## C13 Urban design and visual amenity

This chapter addresses issues raised in community submissions associated with the urban design and visual amenity assessment for the M4-M5 Link Environmental Impact Statement (EIS). Refer to Chapter 13 (Urban design and visual amenity), Appendix L (Technical working paper: Urban design) and Appendix O (Technical working paper: Landscape and visual impact) of the EIS for further detail on the urban design and visual amenity assessment.

**Figure C13-1** Existing active transport connections around the Rozelle Rail Yards

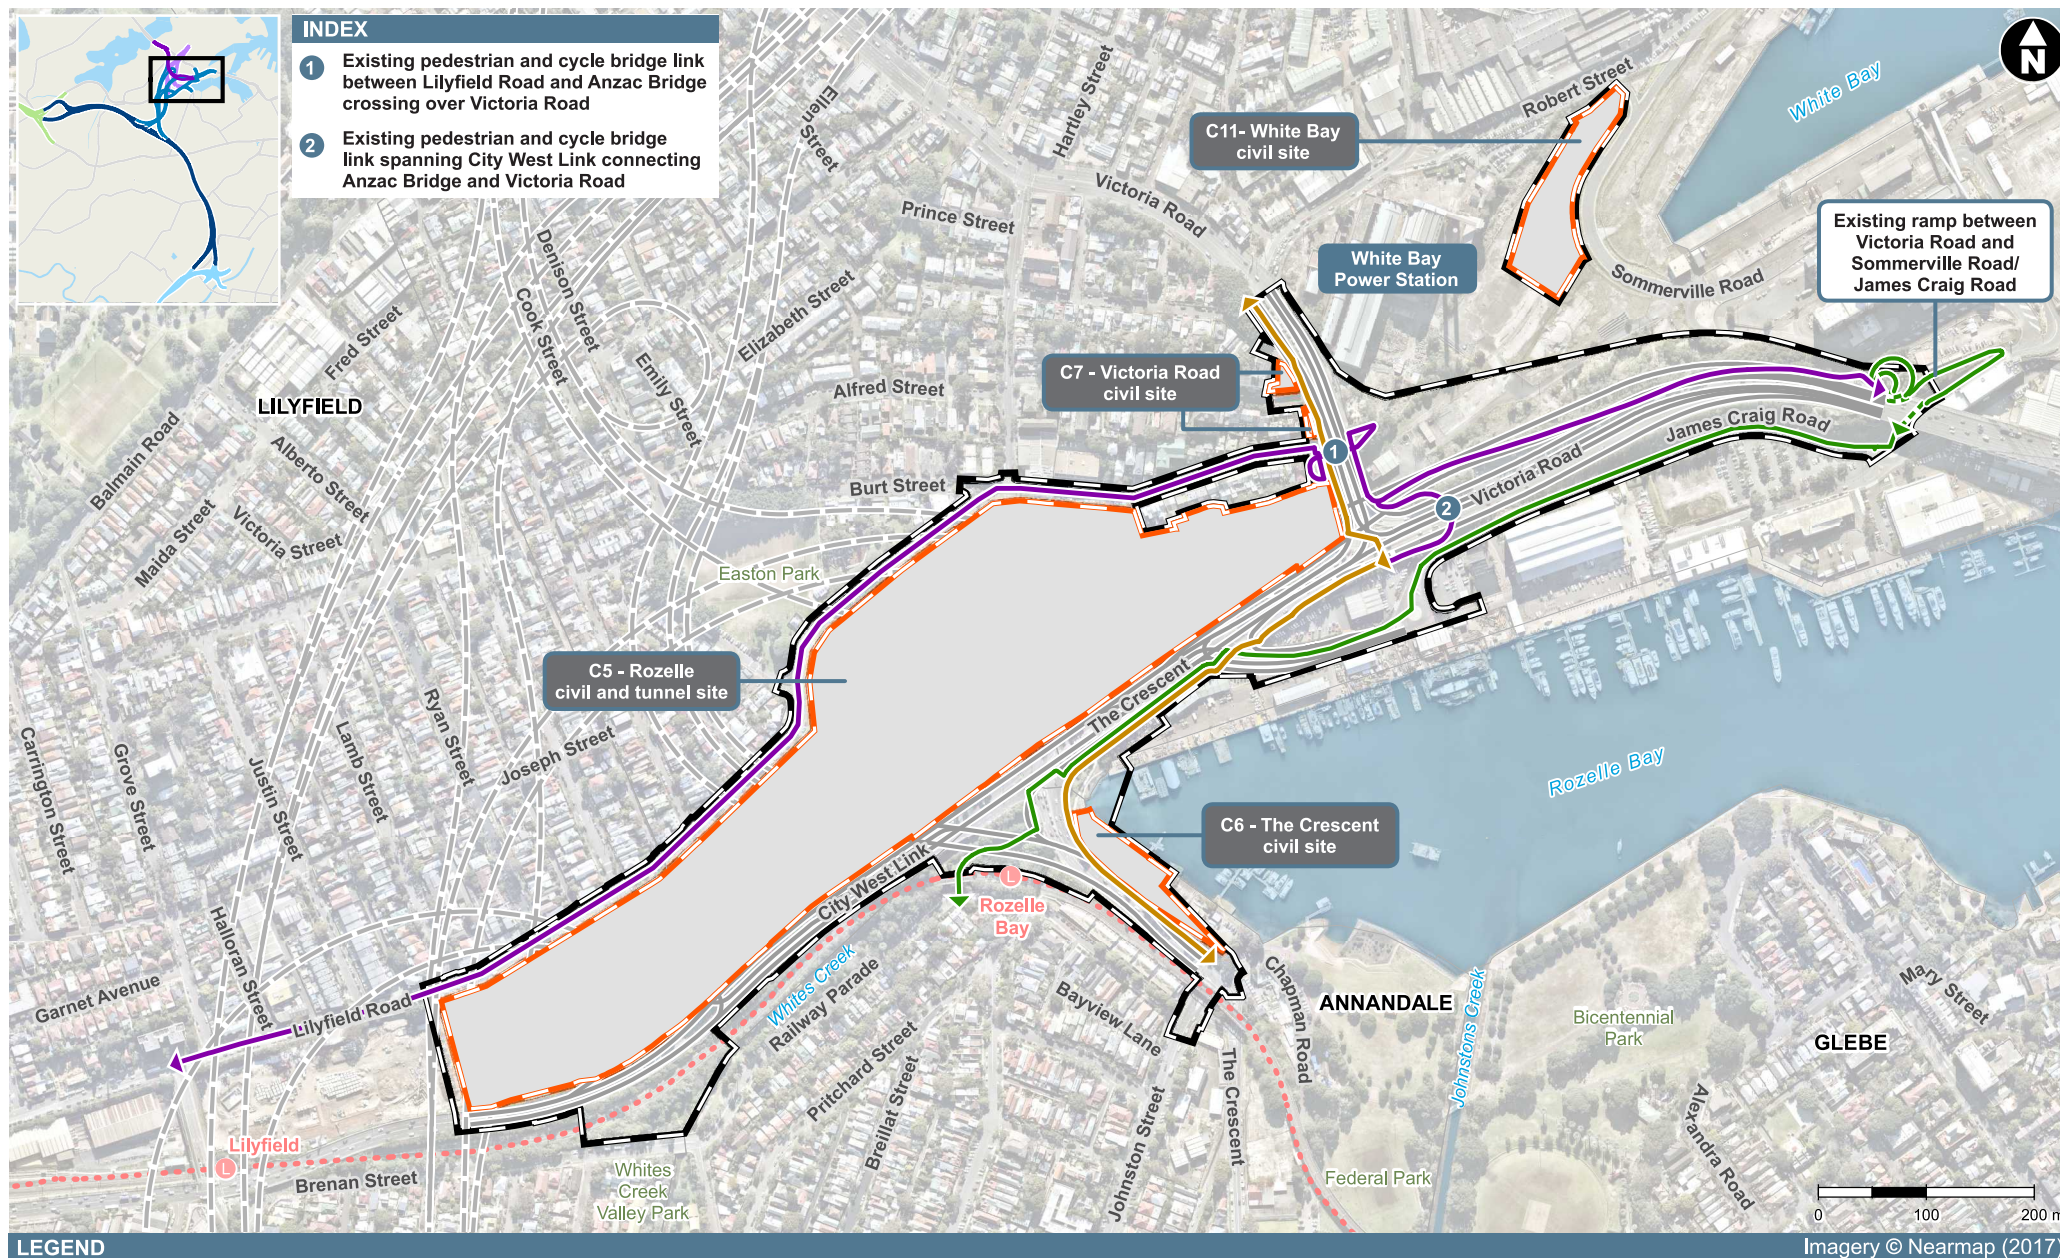
There is an existing active transport connection at Buruwan Park which links Railway Parade to The Crescent under the Inner West light rail line bridge (see **Figure C13-1**). This connection would be temporarily removed during construction. Refer to Table 6-20 of the EIS and **Figure C13-2** for proposed modification to active transport connections during construction.

**Figure C13-2** Proposed temporary changes to active transport connections around the Rozelle Rail Yards during the construction of the project

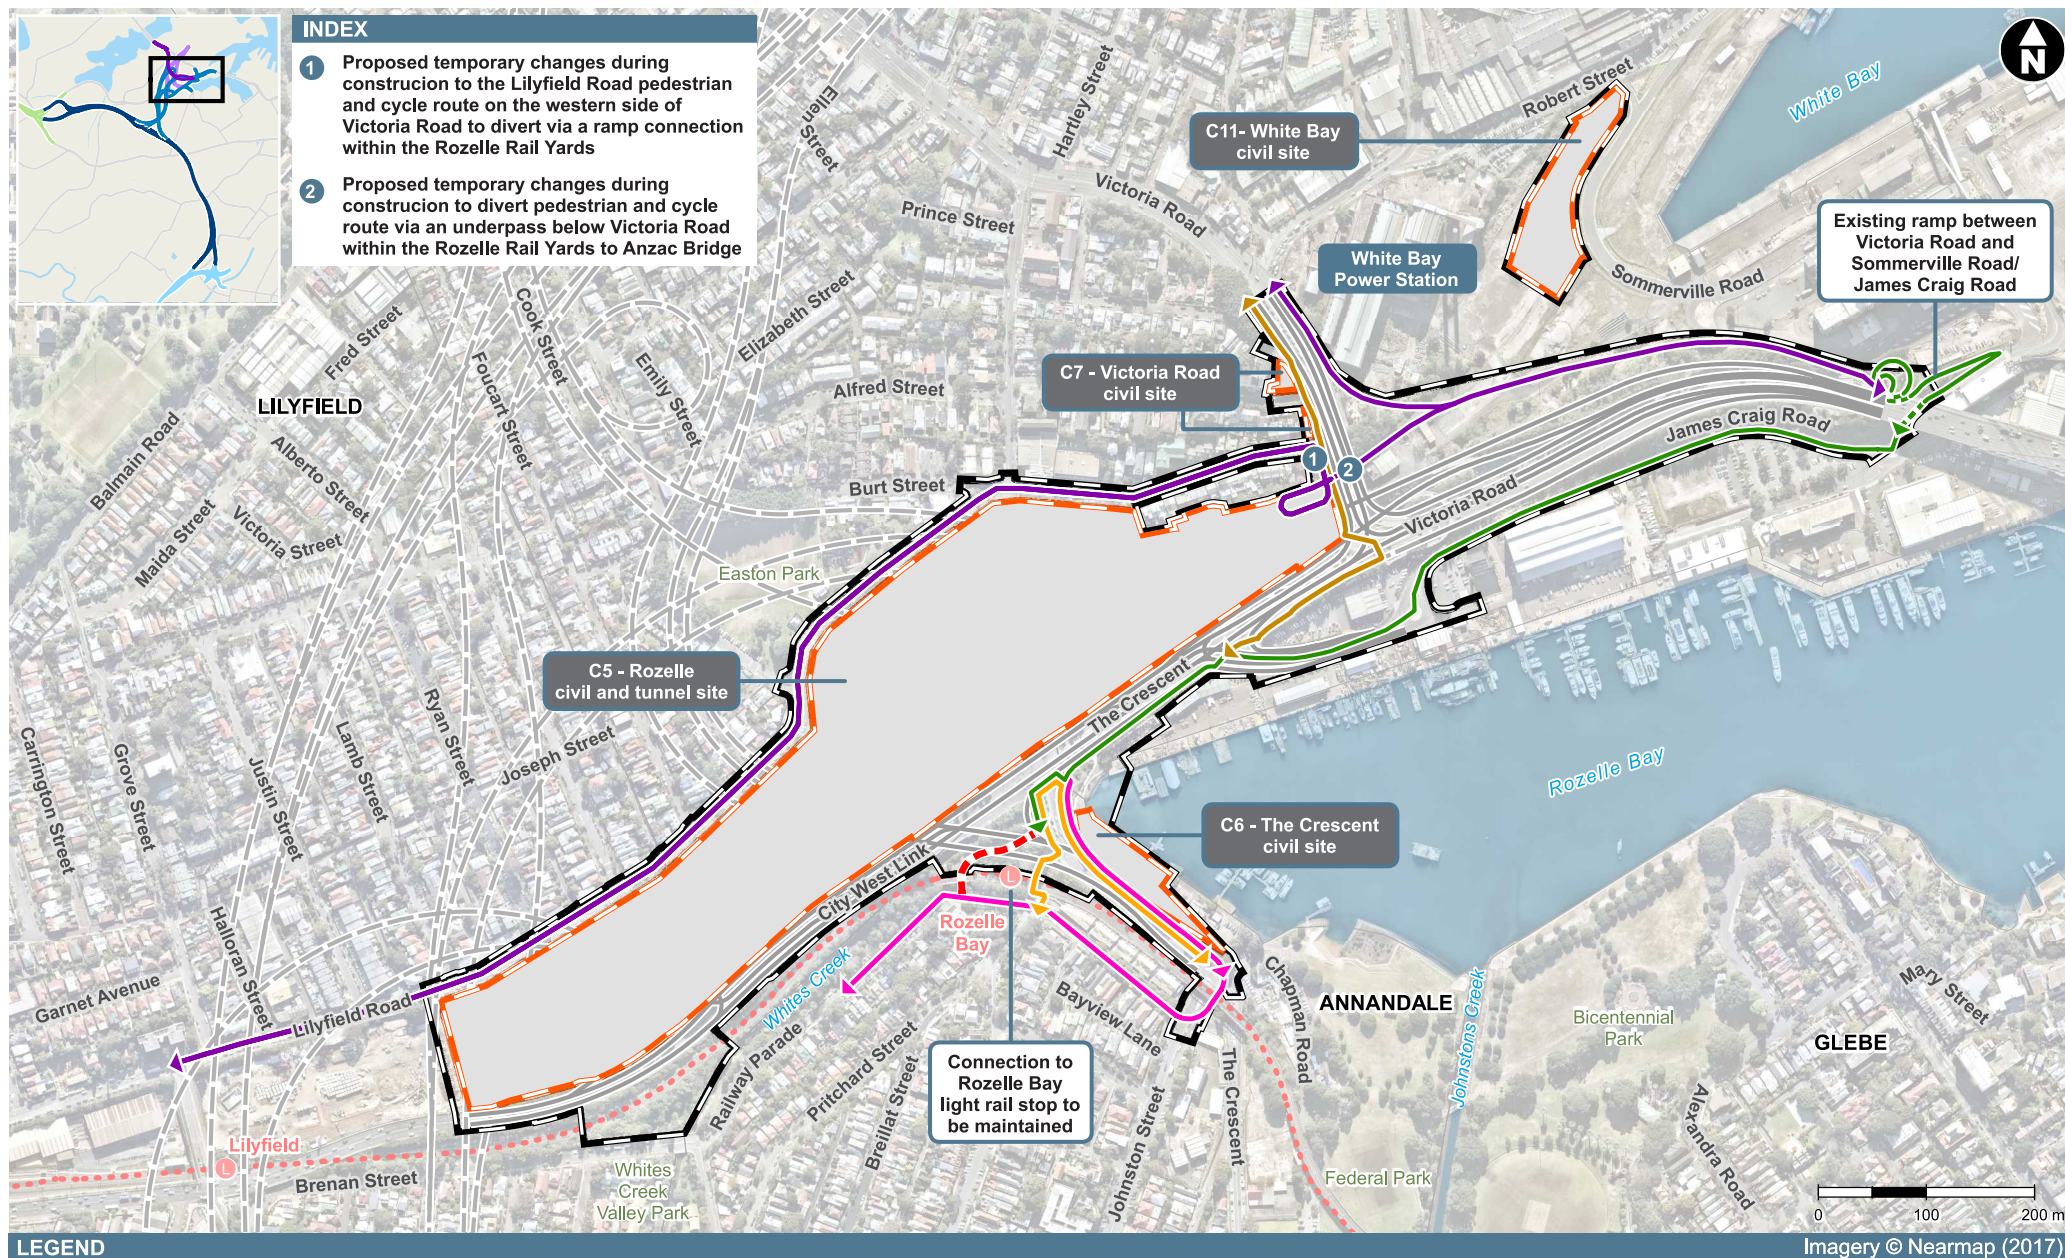
The existing pedestrian bridge over Victoria Road east of the intersection of Victoria Road and The Crescent (identified as 'Beatrice Bush Bridge' by some submitters) would also be removed for widening and adjustments of Victoria Road between The Crescent and Anzac Bridge as part of the Rozelle surface works. Alternative routes for when the bridge is removed during construction are described in Chapter 8 (Traffic and transport) of the EIS and would be established before closure of the bridge. Refer to Table 6-20 of the EIS and **Figure C13-2** for proposed modification to active transport connections during construction.

Figure C13-3 Active transport connections around the Rozelle Rail Yards for the operation of the project

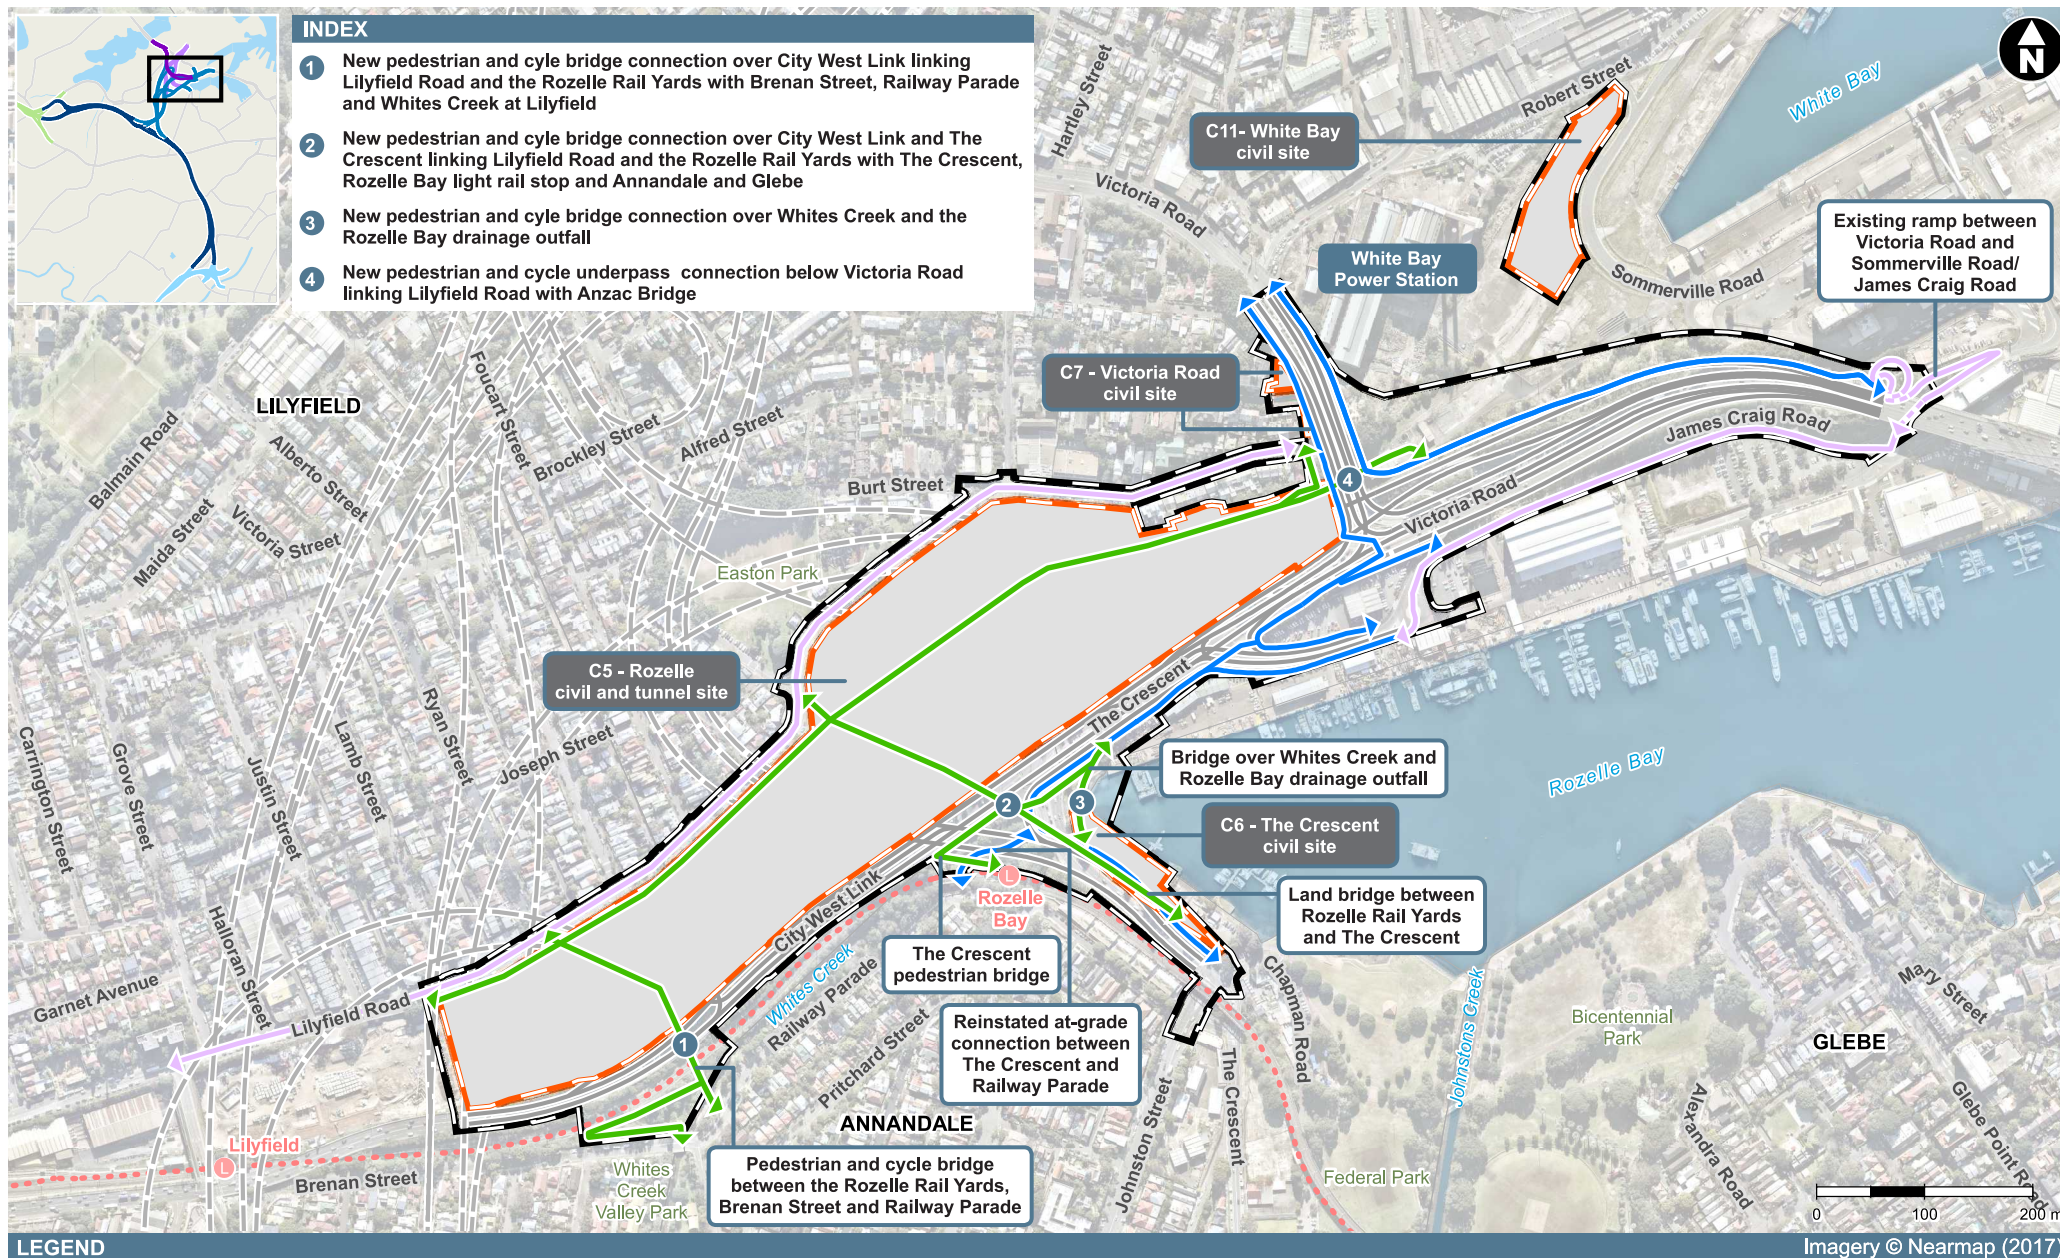
Active transport connections around the Rozelle Rail Yards for the operation of the project are shown in **Figure C13-3**. The active transport connection through Rozelle Rail Yards would connect to the pedestrian and cycle underpass below Victoria Road. This link would connect with the existing shared path located to the north of Victoria Road towards Anzac Bridge.
